PMSTPCOL PEmails

February 10, 2010
U7-C-STP-NRC-100036

South Texas Project
Units 3 and 4
Docket Nos. 52-012 and 52-013
Response to Request for Additional Information

Attached are the responses to the NRC staff questions included in Request for Additional Information (RAI) letter numbers 299 and 302 related to Combined License Application (COLA) Part 2, Tier 2, Sections 3.7.1, 3.7.2 and 3.8.4.

Figure 03.08.04-17a: DCD total at-rest lateral soil pressure excluding SSE increment, H, for design of RB walls

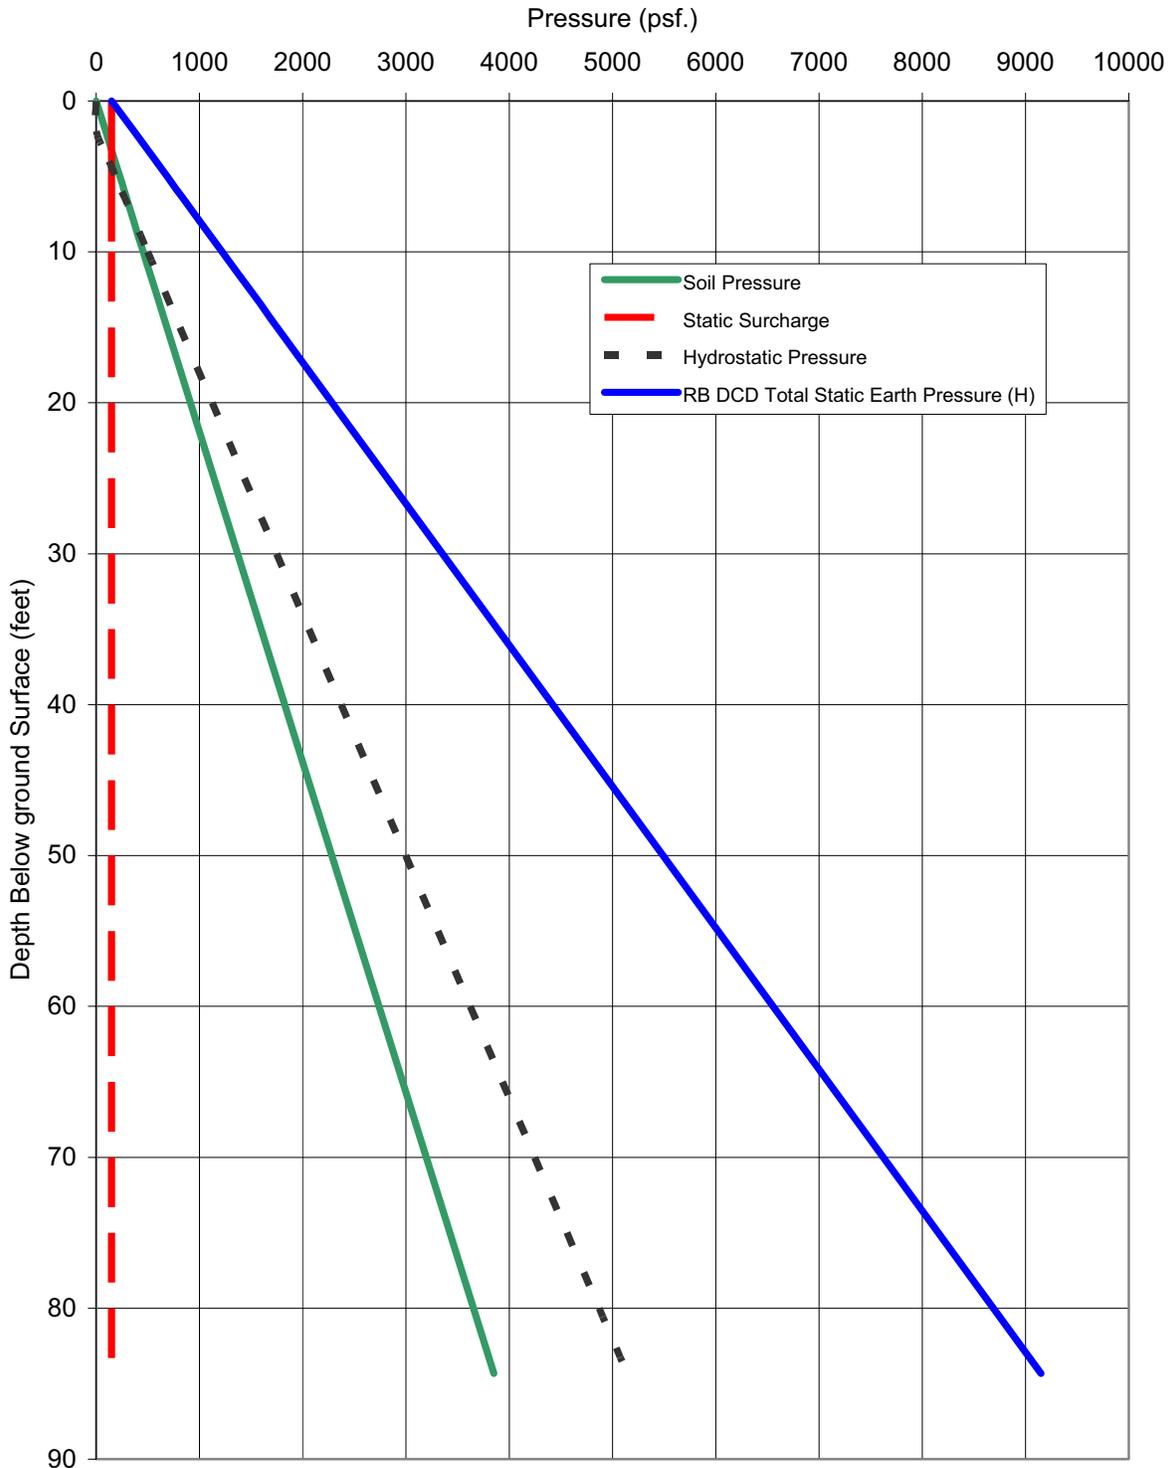
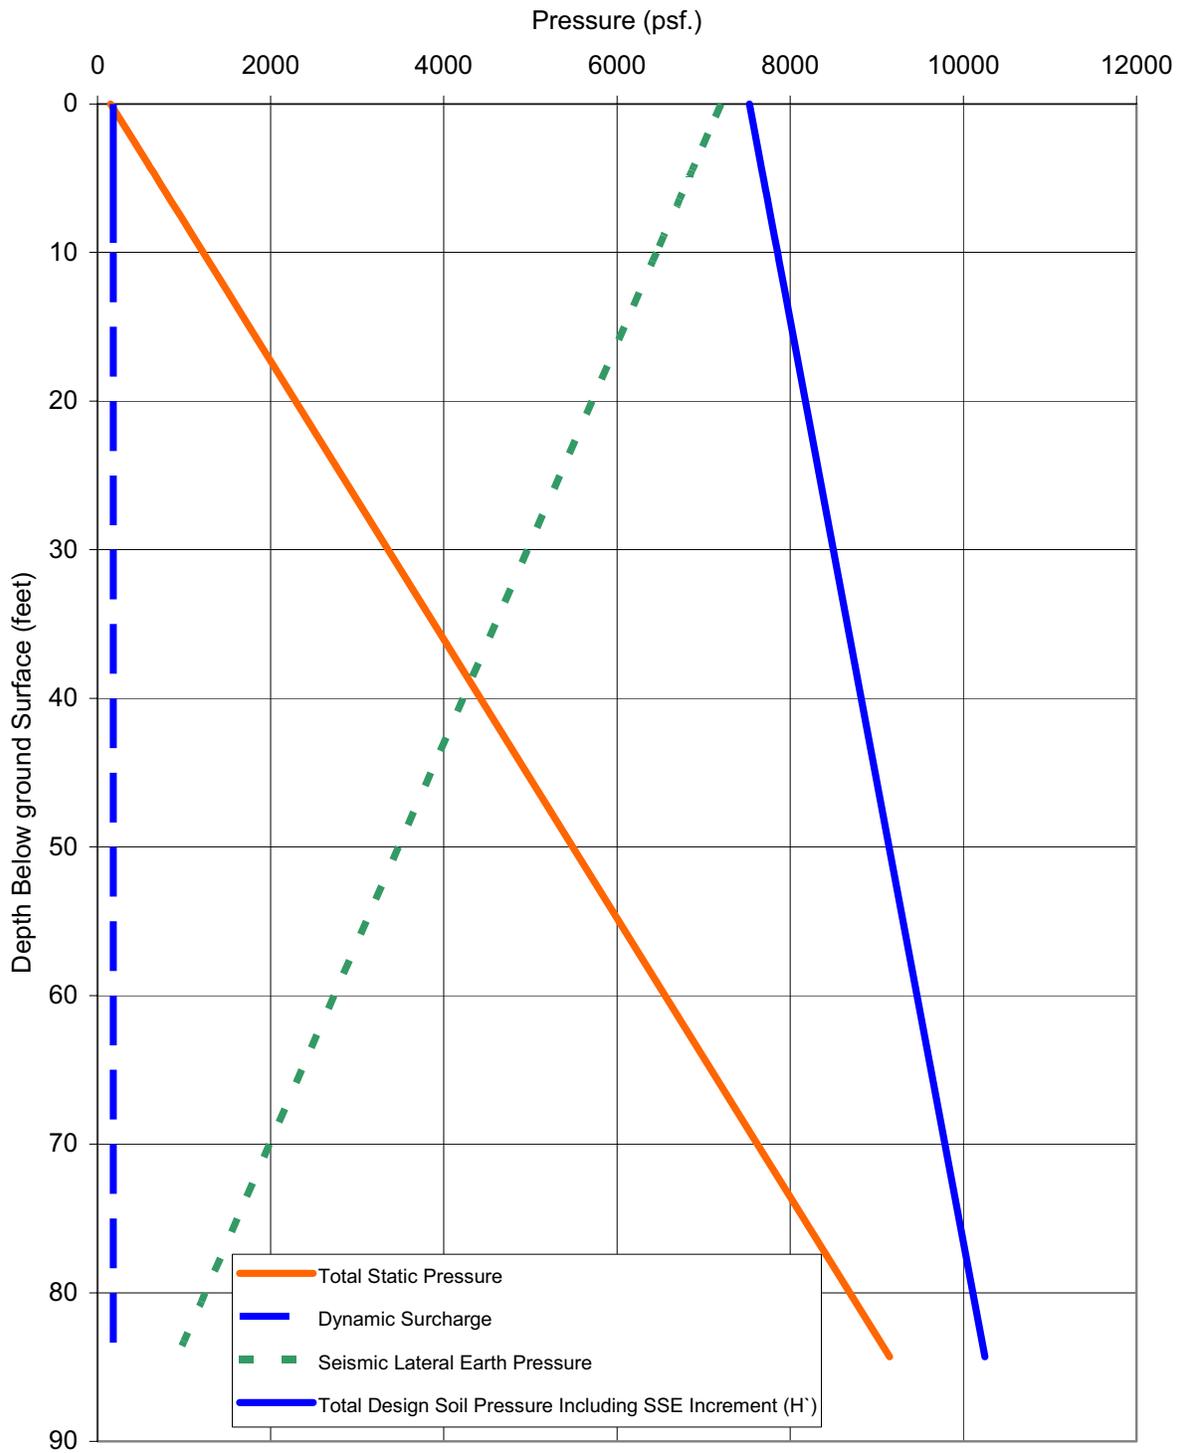
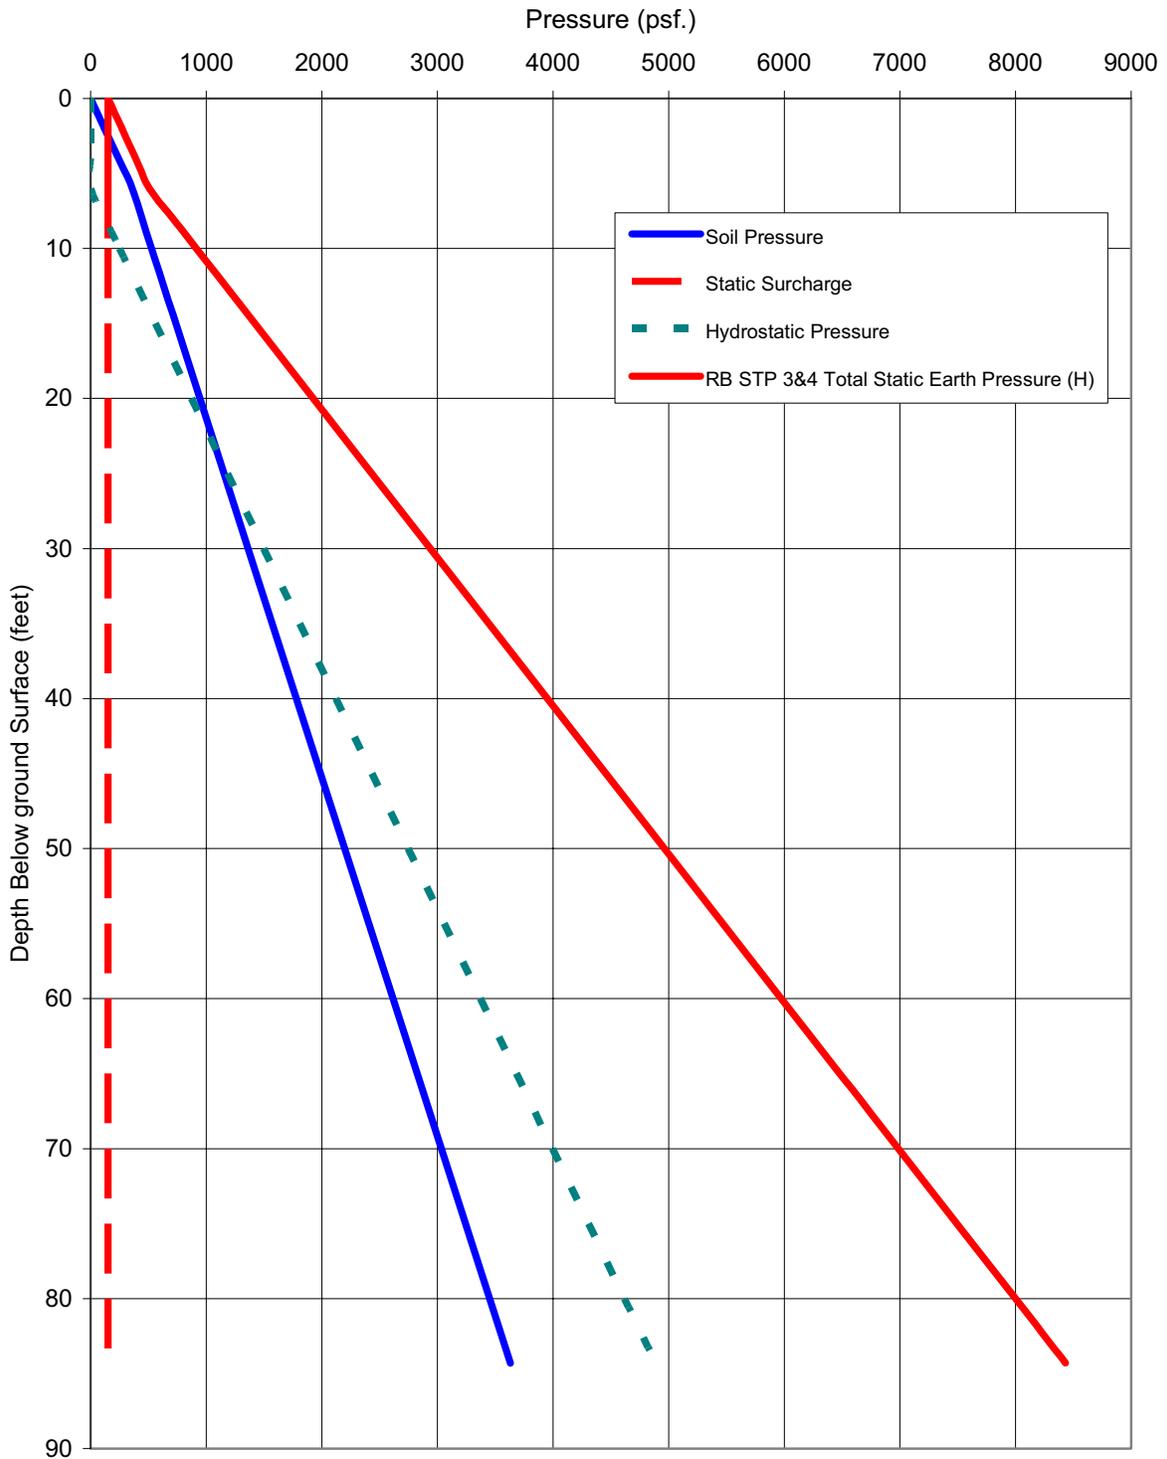
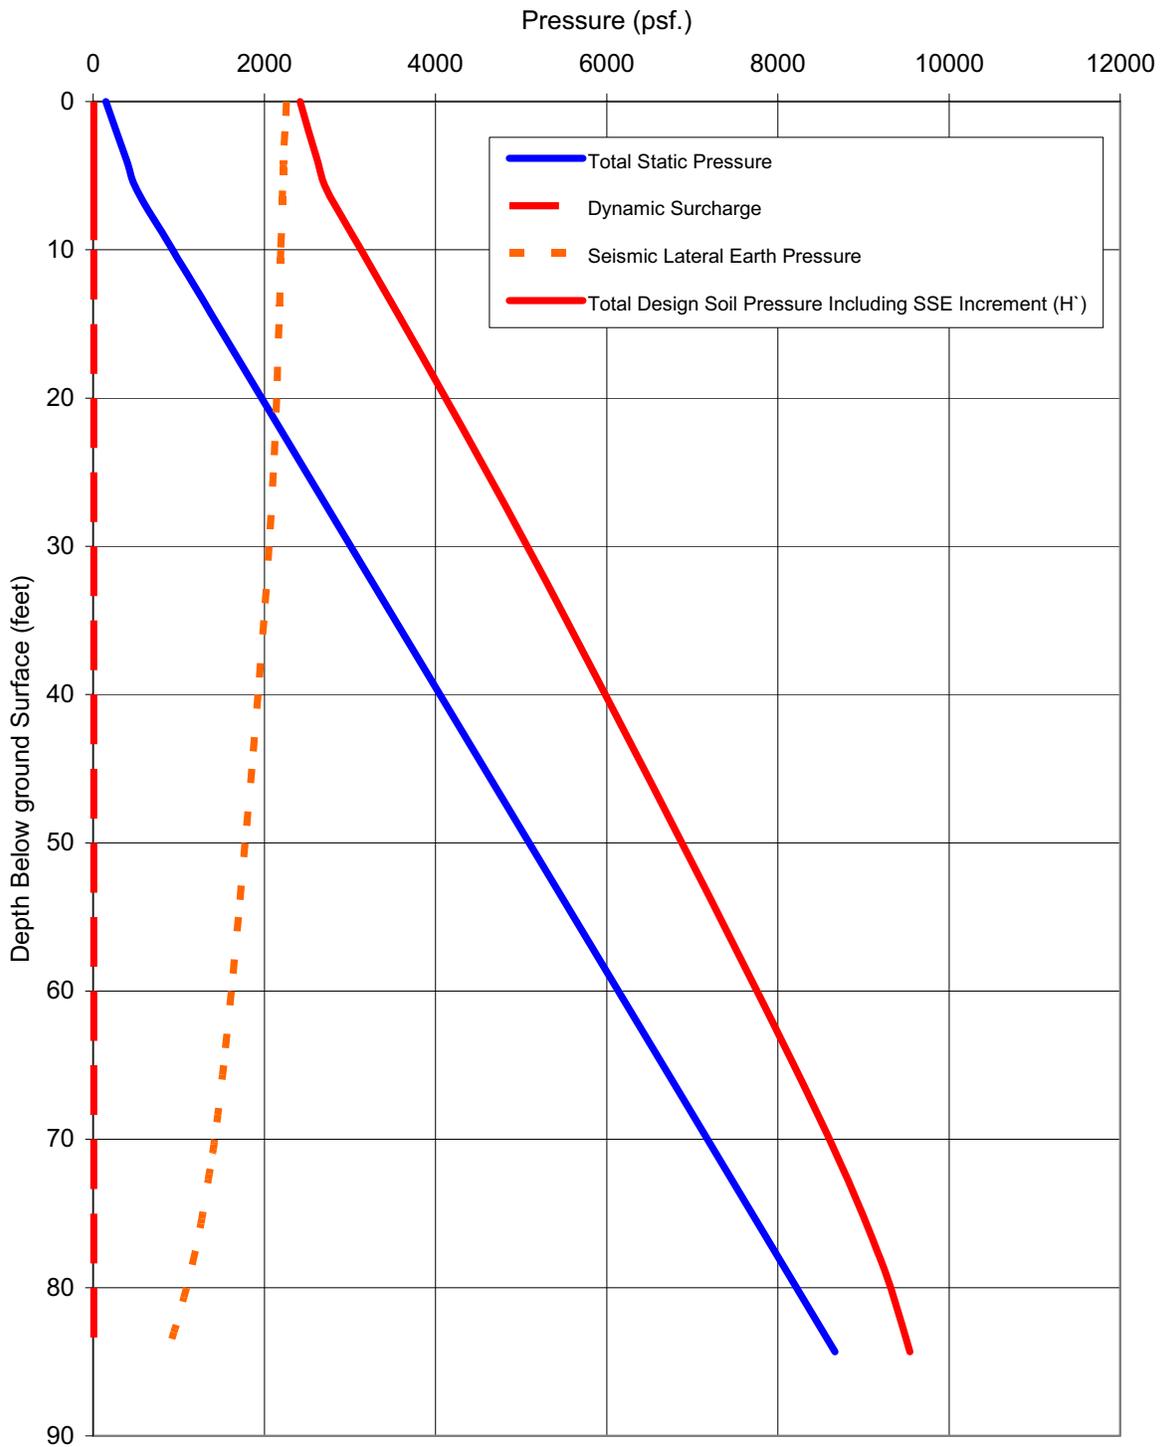
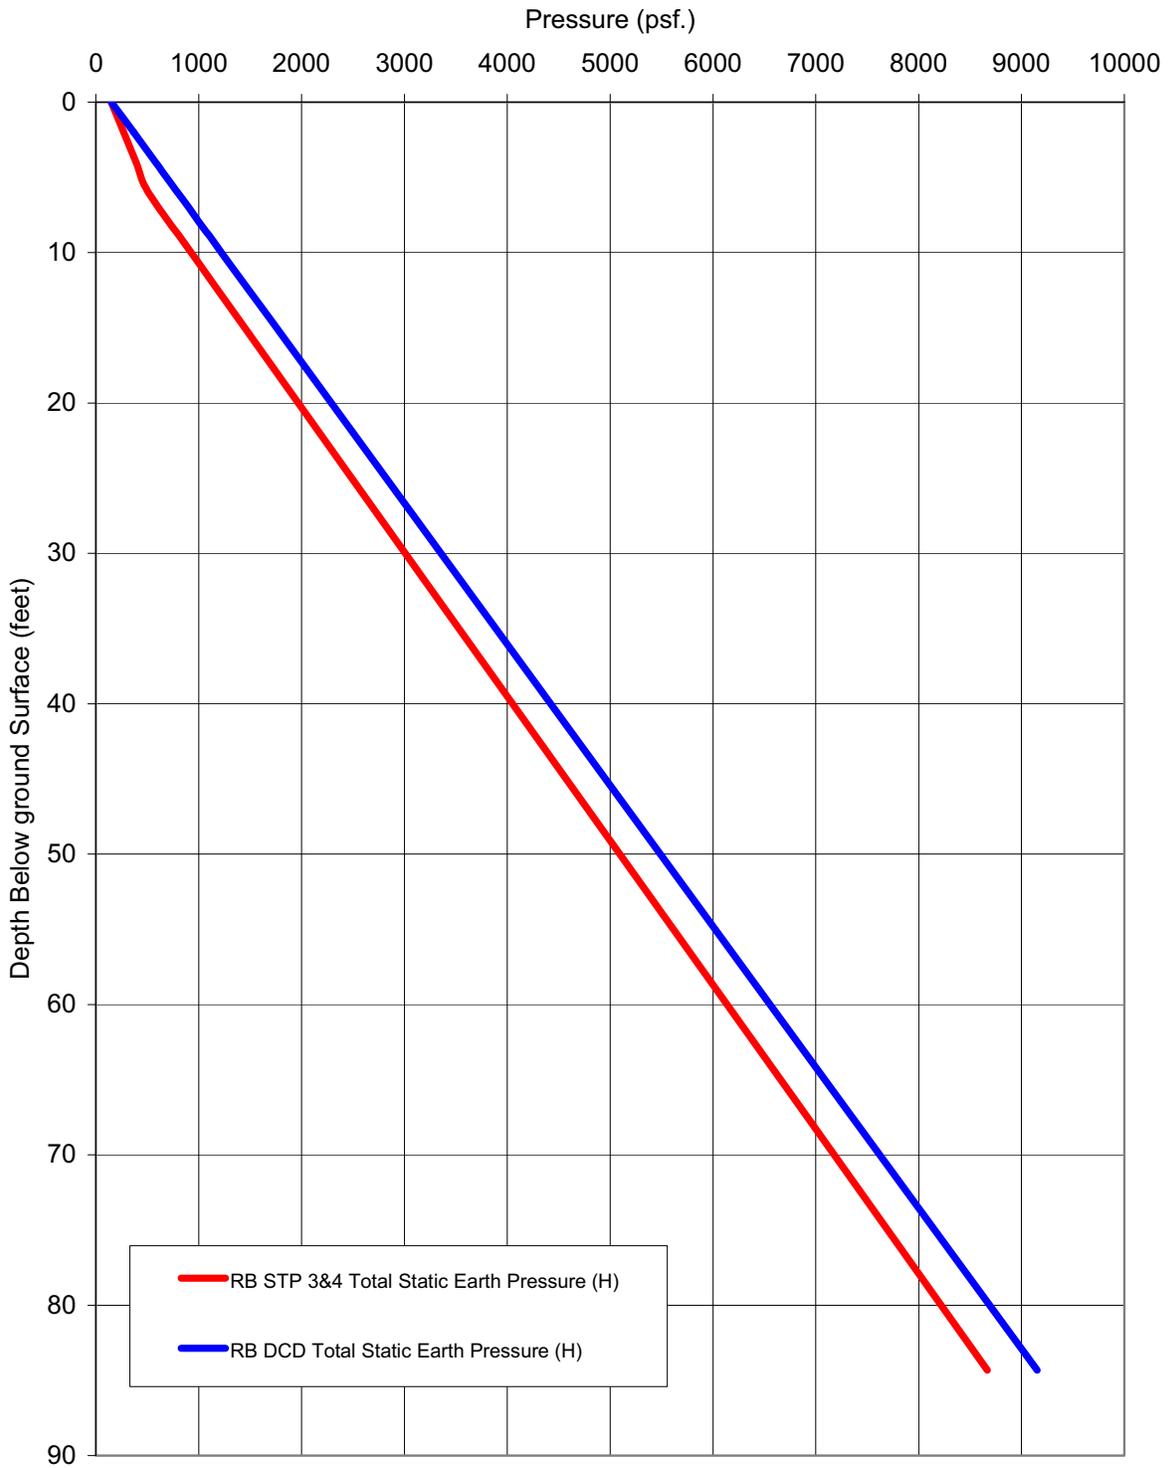
- b) Per Sections 3H.1.4.3.1.8 and 3H.1.5.5.3.1 of the ABWR DCD, Tier 2, the lateral soil pressures used for the design of Reactor Building (RB) walls are provided in Figure 3H.1-11 of DCD Tier 2. Also, per Section 3H.2.4.3.1.4 of DCD Tier 2, the lateral soil pressures used for the design of Control Building (CB) walls are provided in Figure 3H.2-14 of DCD Tier 2.

Figures 03.08.04-17a through 03.08.04-17l on the following pages provide the following:
